SECTION 905 -- PROPOSAL (CONTINUED)

Number	Description
1	Revised Table of Contents; Add Notice To Bidders #586; Add Special Provision 907-687-1; Replace Bid Sheets with Same; Revised Diskette Required.

PROJECT: HSIP-0055-02(204) N / 104902301 – Hinds County

SUBJECT: Vehicle Classification and Axle Detector (VCAD) Systems

TYPICAL DETAIL FOR VEHICLE CLASSIFICATION INDUCTIVE LOOP

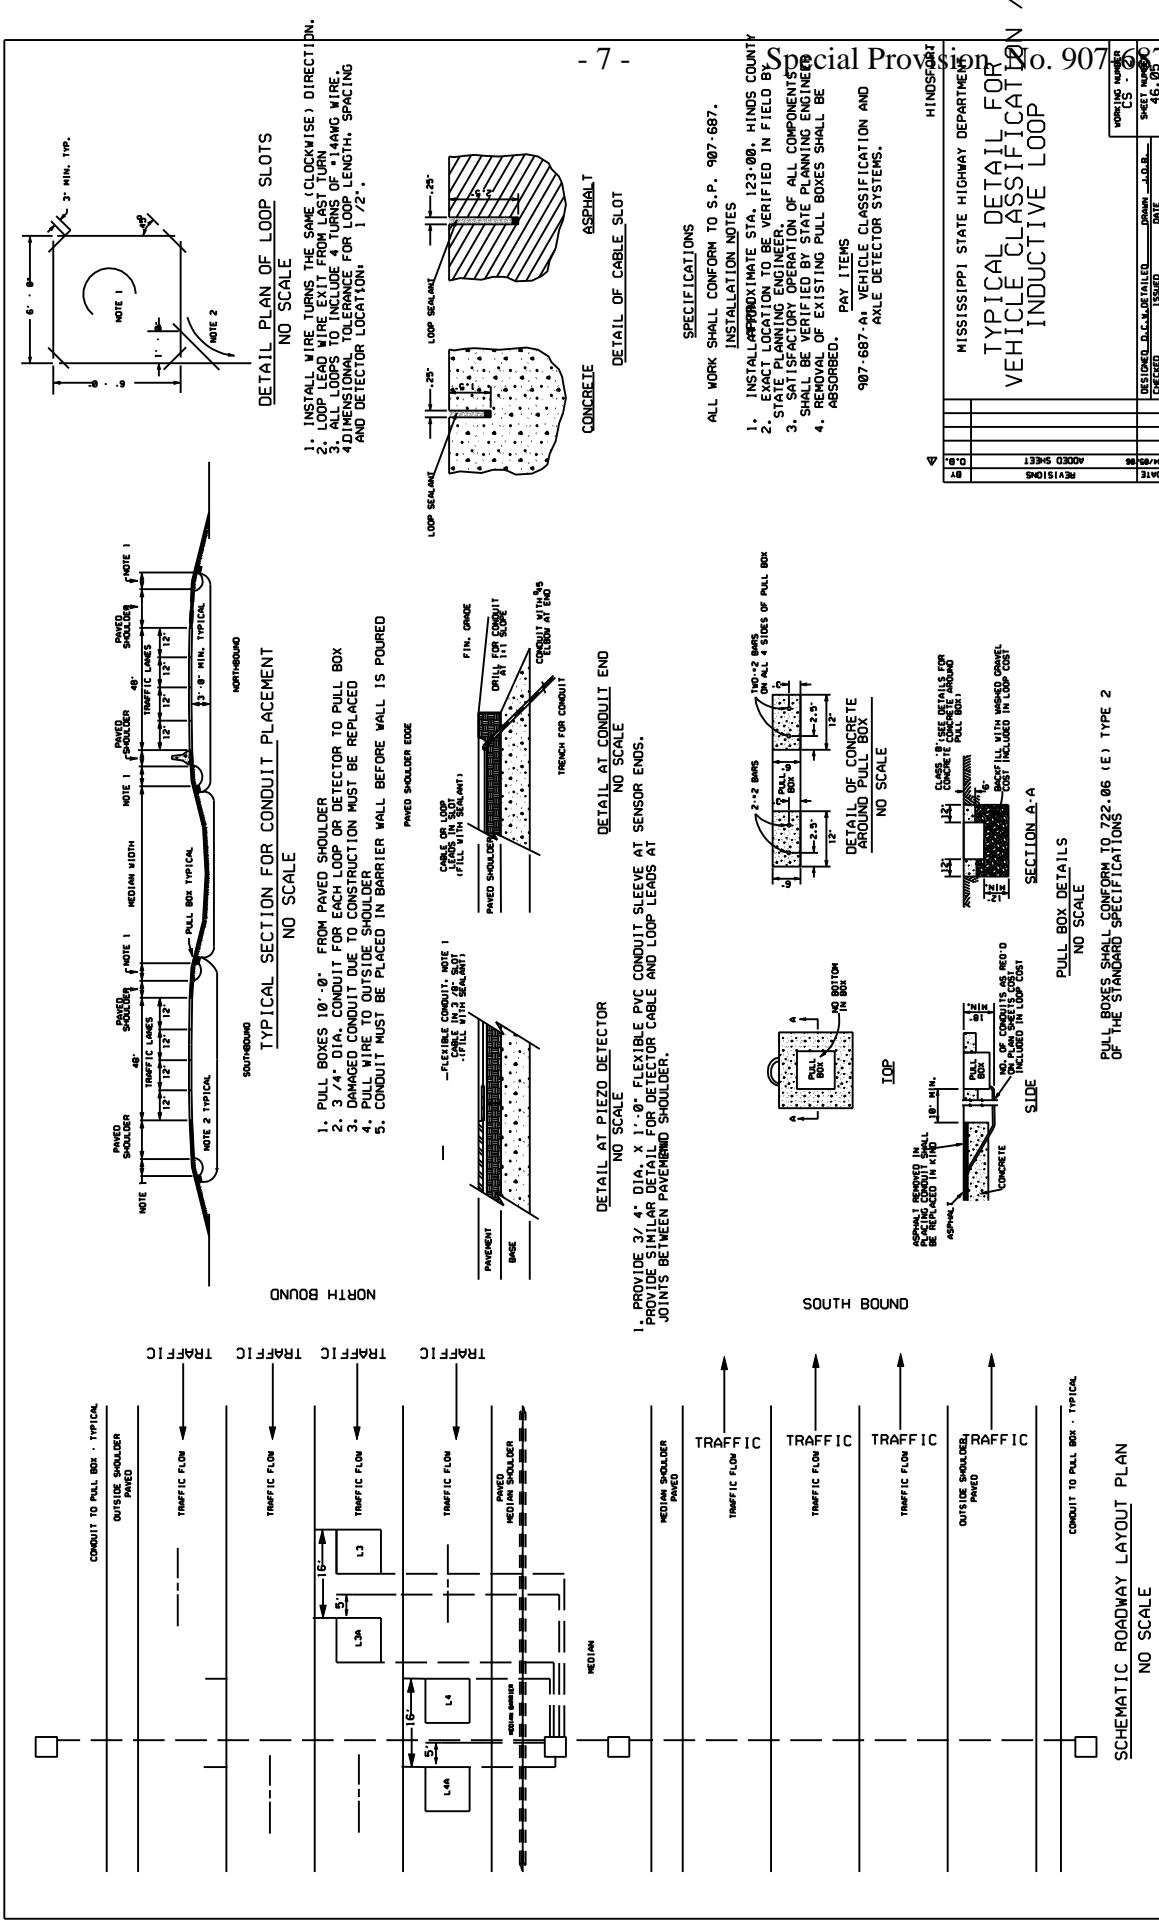
1. PROVIDE 2/4" DIA. X 1'-0" FLEXIBLE PVC CONDUIT SLEEVE AT SENSOR ENDS. PROVIDE SIMILAR DETAIL FOR DETECTOR CABLE AND LOOP LEADS AT JOINTS BETWEEN PAVEMENT SHOULDERS.

1. INSTALL APPROXIMATE STA. 123+00, HINDS COUNTY STATE PLANNING ENGINEER
2. STATE PLANNING ENGINEER
3. SATISFACTORY OPERATION OF ALL COMPONENTS SHALL BE VERIFIED BY STATE PLANNING ENGINEER
4. REMOVAL OF EXISTING PULL BOXES SHALL BE ABSORBED.

TYPICAL DETAIL FOR VEHICLE CLASSIFICATION INDUCTIVE LOOP

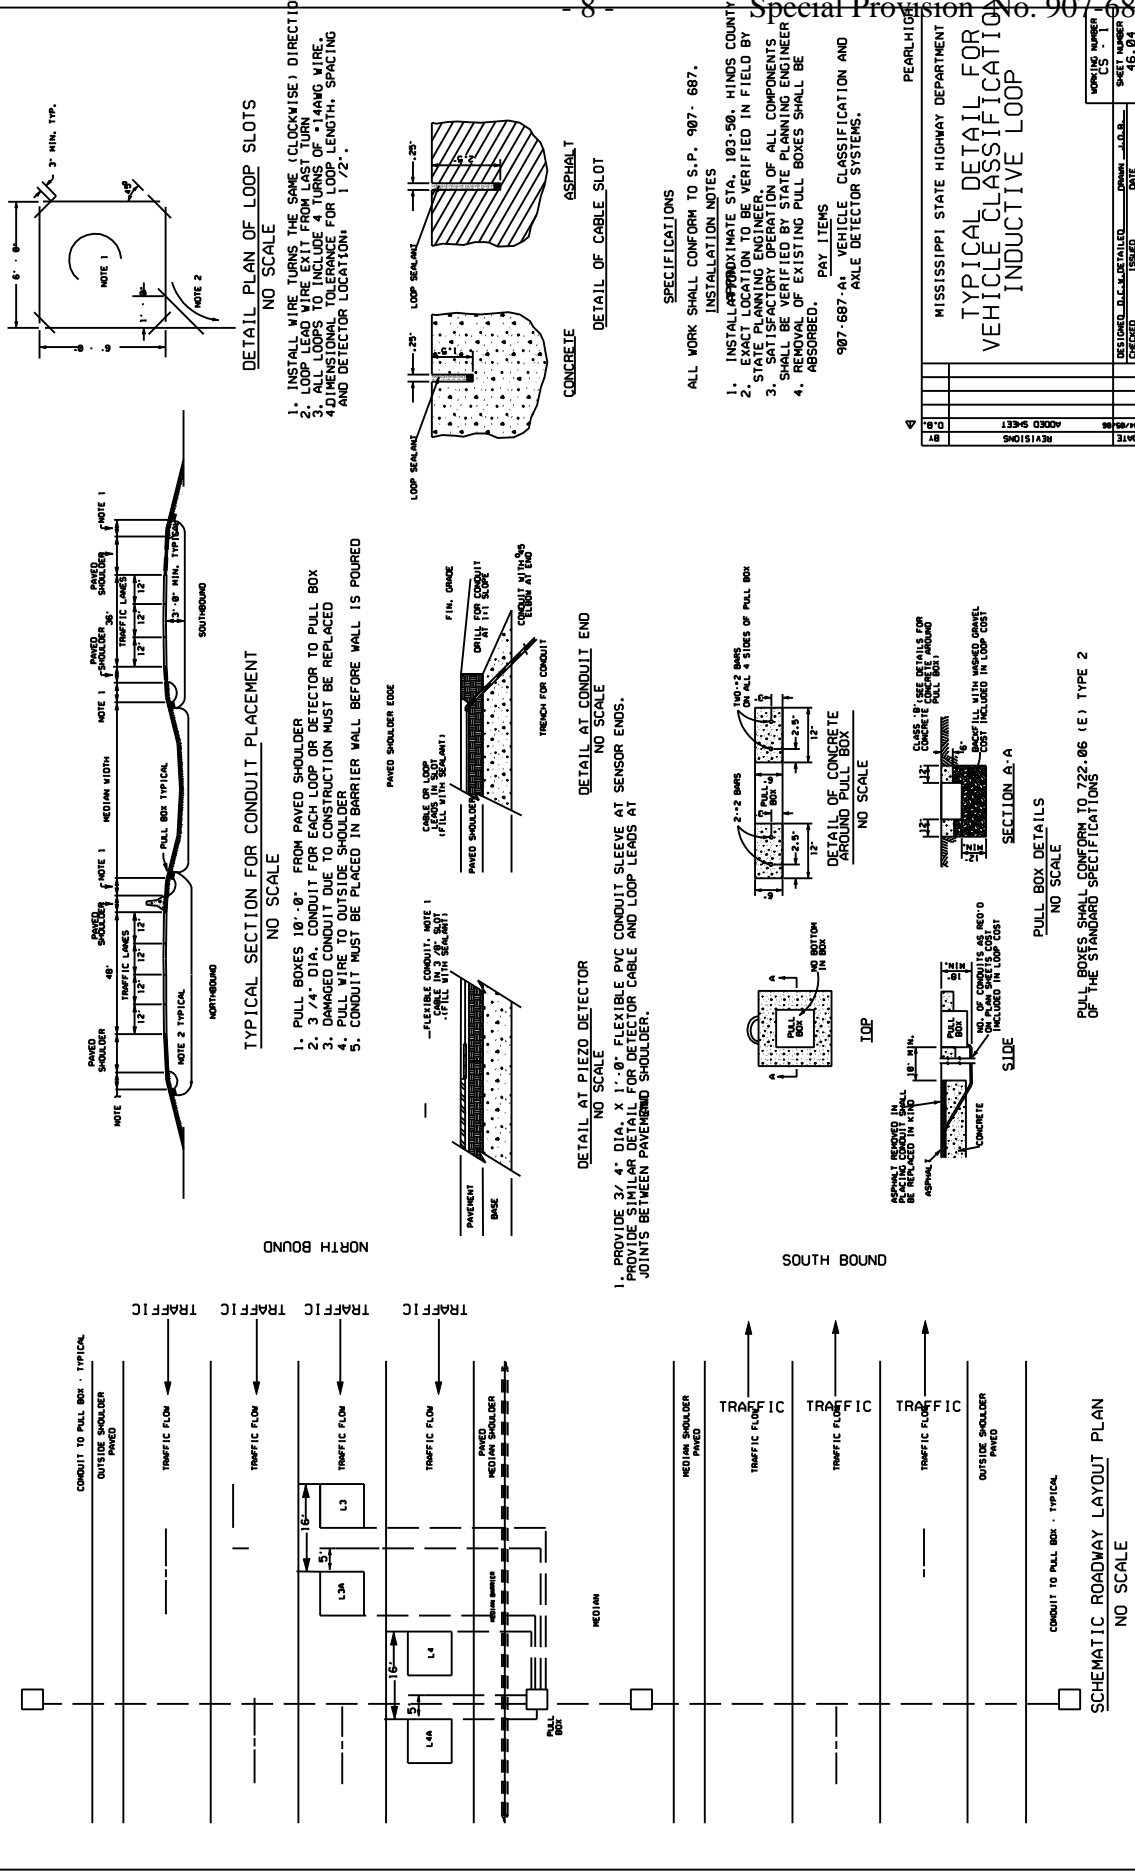
1. PROVIDE 3/4" DIA. X 1'-0" FLEXIBLE PVC CONDUIT SLEEVE AT SENSOR ENDS.
2. PROVIDE SIMILAR DETAIL FOR DETECTOR CABLE AND LOOP LEADS AT JOINTS BETWEEN PAVEMENT SHOULDERS.

1. INSTALL APPROXIMATE STA. 103+50.0 HINDS COUNTY
2. EXACT LOCATION TO BE VERIFIED IN FIELD BY STATE PLANNING ENGINEER.
3. SATISFACTORY OPERATION OF ALL COMPONENTS SHALL BE VERIFIED BY STATE PLANNING ENGINEER
4. REMOVAL OF EXISTING PULL BOXES SHALL BE ABSORBED. PAY ITEMS 907-687-A1 VEHICLE CLASSIFICATION AND AXLE DETECTOR SYSTEMS.
